TO: Ryanne Sass, Plaza Street Partners
FROM: Stacey Nerger, Senior Planner
DATE: October 11, 2022
SUBJECT: Lincoln Professional Park – Preliminary Site Plan
Review Comments 05

LINCOLN PROFESSIONAL PARK FILING NO.1 PRELIMINARY SITE PLAN

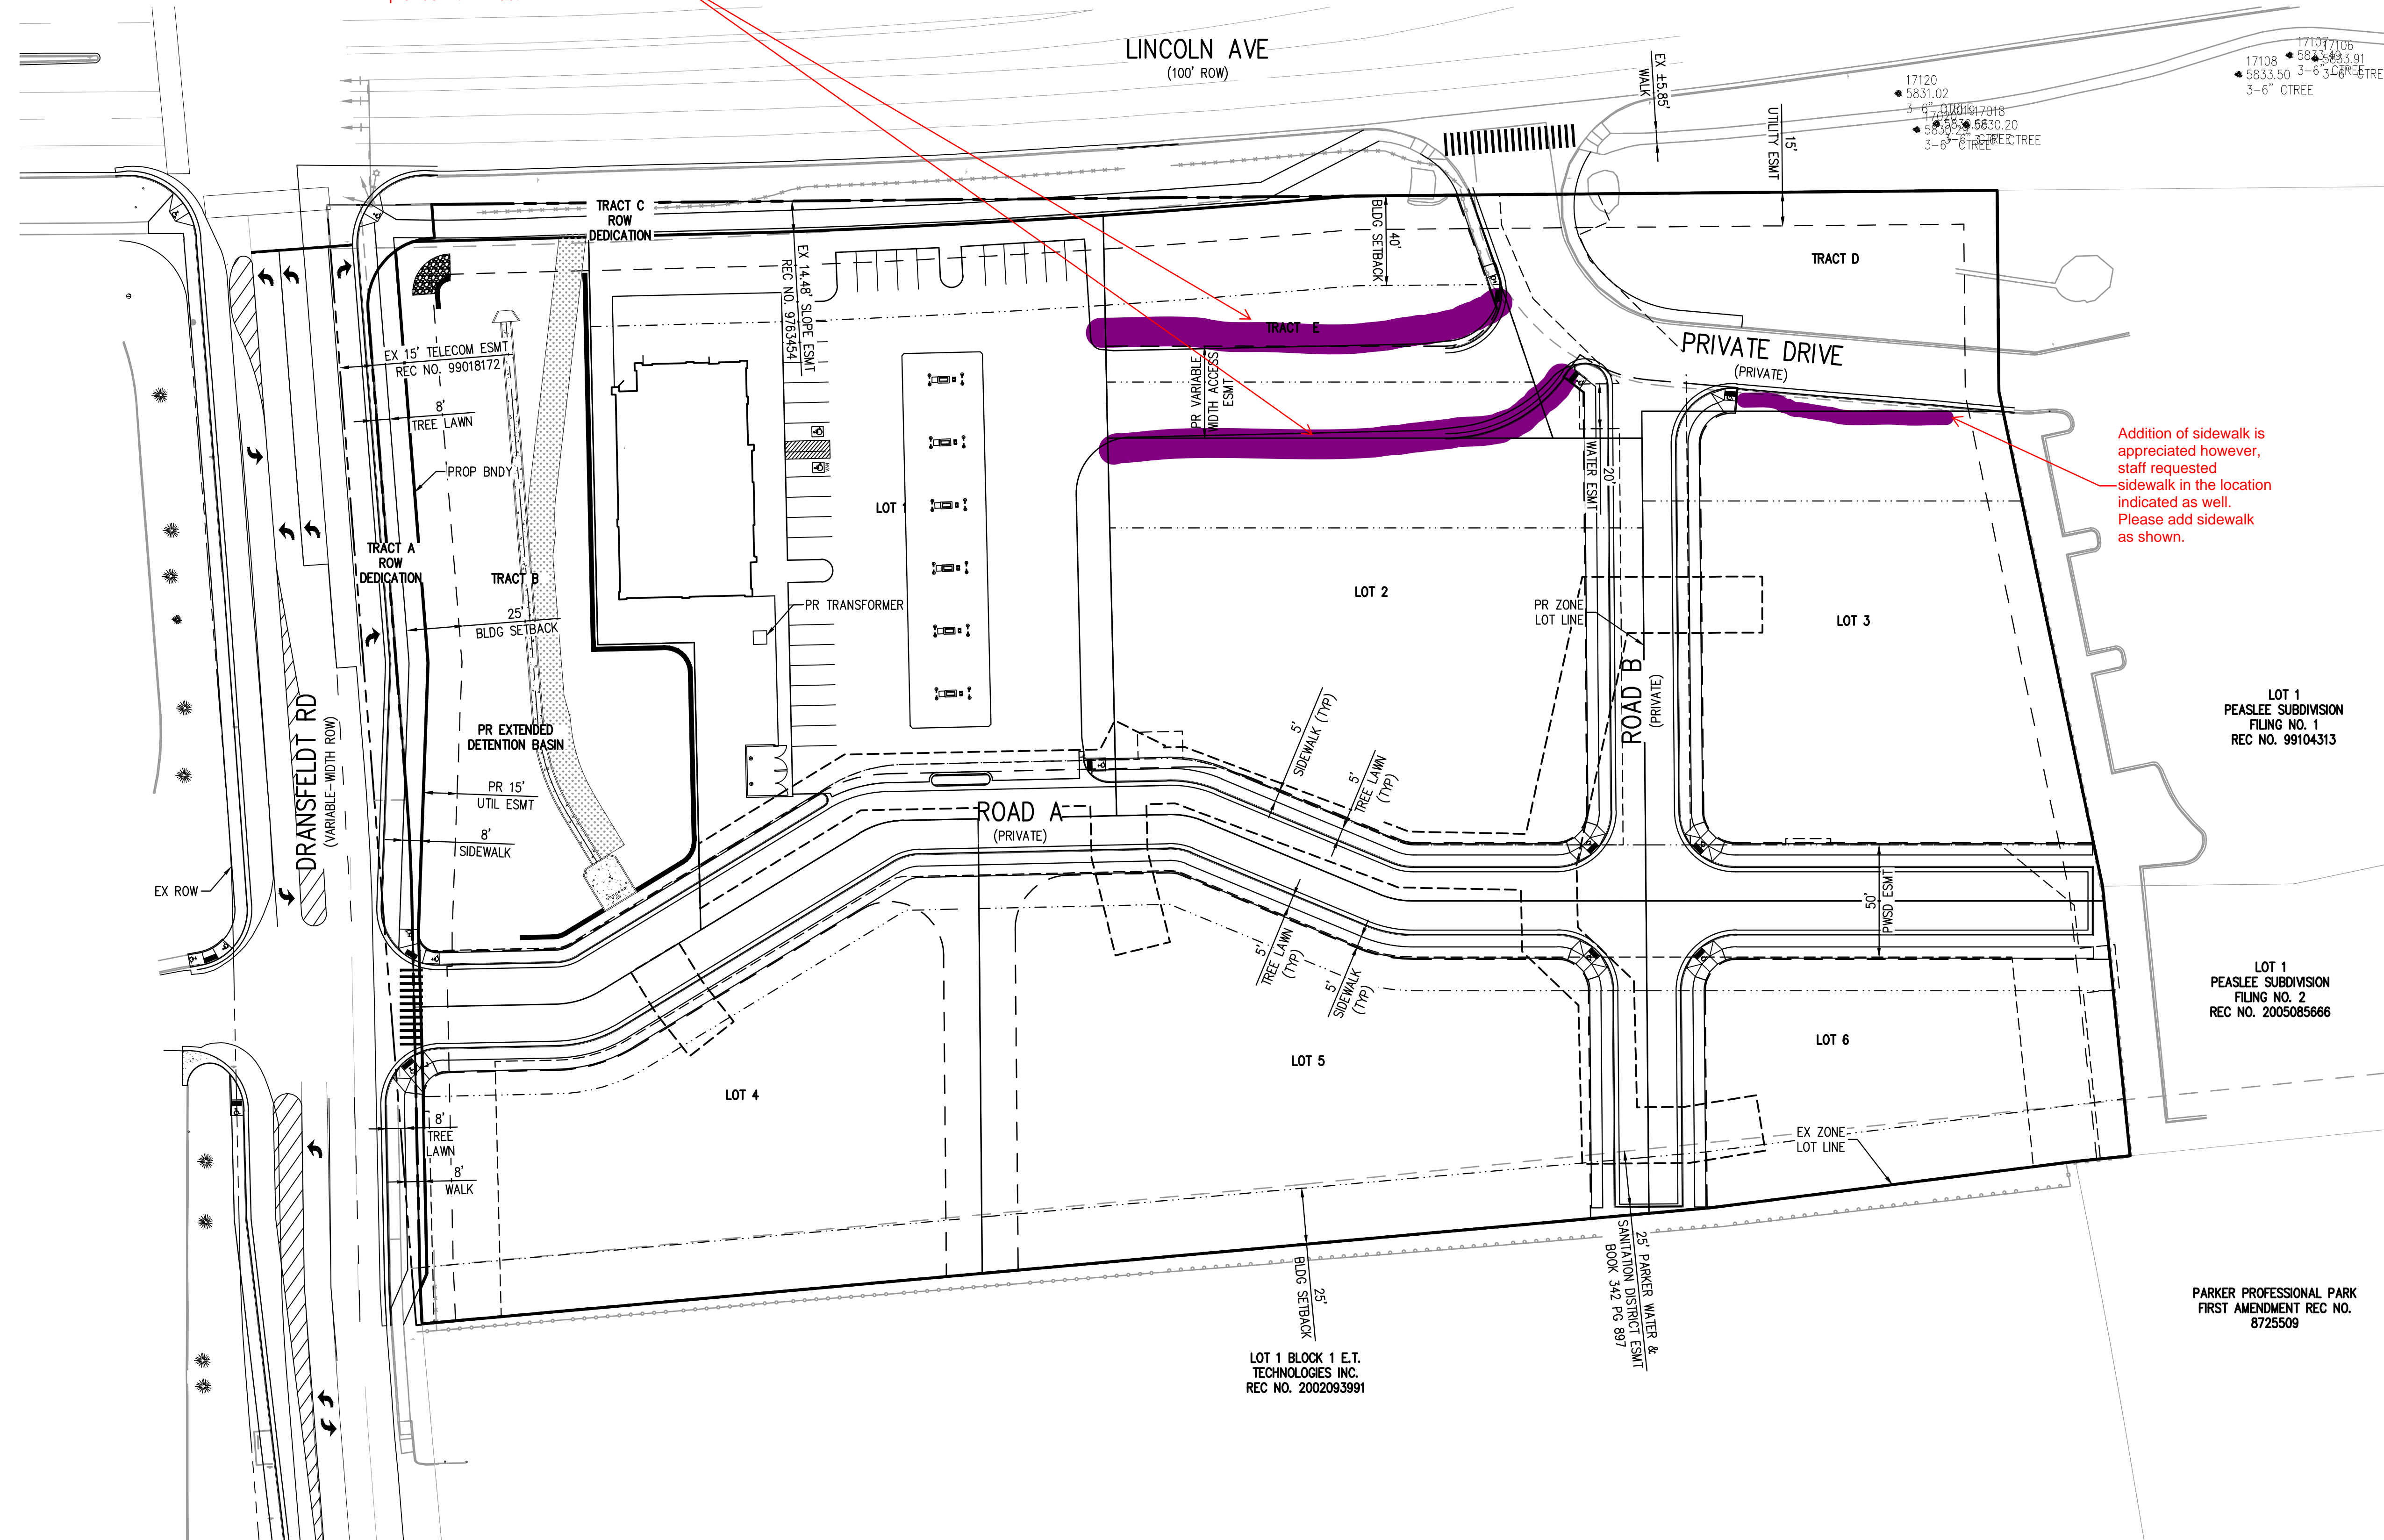
Sorry for missing this in the previous review. But please add a sidewalk to at least one side of this internal road. It may be easier to provide within Tract E.

Addition of sidewalk is appreciated however, staff requested sidewalk in the location indicated as well. Please add sidewalk as shown.

LANDSCAPE PLAN
SHEET 3 OF 5

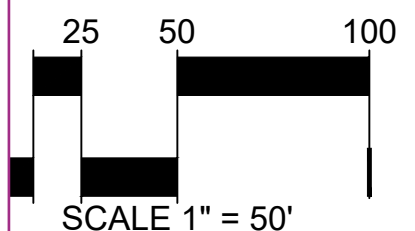
Add street trees along the side of the internal road where the new sidewalk is added. Assuming it will be on the north.

As discussed with the applicant, since this tract is not buildable. Landscaping will need to be provided at the time of MDP. The entire tract shall be landscaped. Please include a minimum of 1 tree and 5 shrubs per 1,500 sq. ft. of landscaped area. Trees and shrubs can be grouped.

Addition of sidewalk is appreciated however, staff requested sidewalk in the location indicated as well. Please add sidewalk as shown.

Due to utility conflicts shrubs were added instead. Please include a column for the number of shrubs provided. Based on the Town LDO, 10 shrubs can equal 1 tree.

Staff comment indicates these calcs should remain the same. They have increased. The response from the applicant indicates that the radii (only) have been omitted from the calculation. Staff believes these numbers should have decreased? Please clarify. Additionally, these numbers affect the minimum street tree requirement, please verify that these changes remain in compliance with street tree requirements. Verification needs to appear in writing.

Entries and exits have been subtracted from calculations for Lincoln and Dransfeldt. For internal streets, radii at intersections have been omitted from calculations but potential access for lots has remained included.
